Memo

To: Zoning Board Chairperson McGinley and Secretary Miesch
From: Plan Review Committee of the Verona Environmental Commission
c: Verona Environmental Commission Chair
Date: May 1, 2026
Re: **Case # 2026-10**
257 Pompton Avenue [Block 104, Lot 1]
Verona, New Jersey
Zone: C-2 (Professional Office and Business)

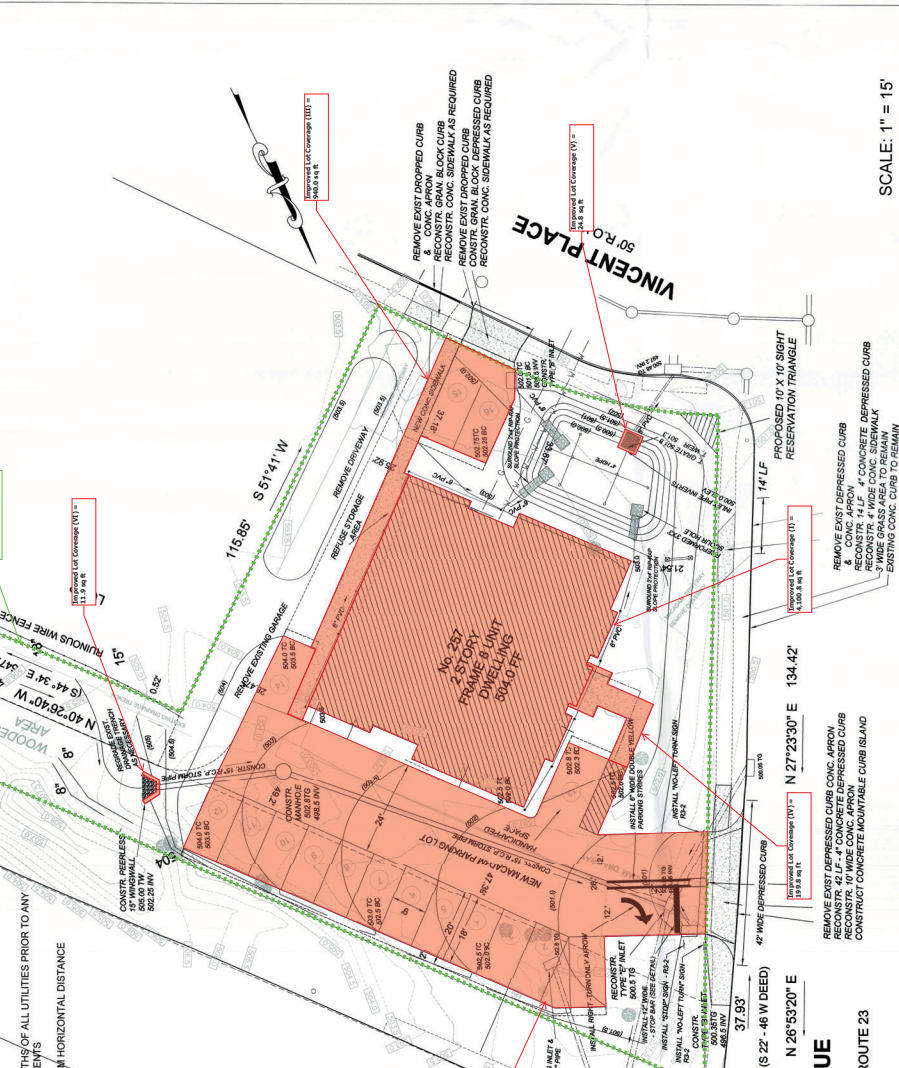
- 9) The Drainage Pipe Trench Detail on the SITE PLAN drawing details ¾-inch crushed stone pipe bedding surrounding the pipe. A filter fabric (such as the Mirafi 140N geotextile) should envelop the crushed stone pipe bedding, otherwise fines from surrounding soils will migrate into voids of bedding causing settlement of ground surface above.
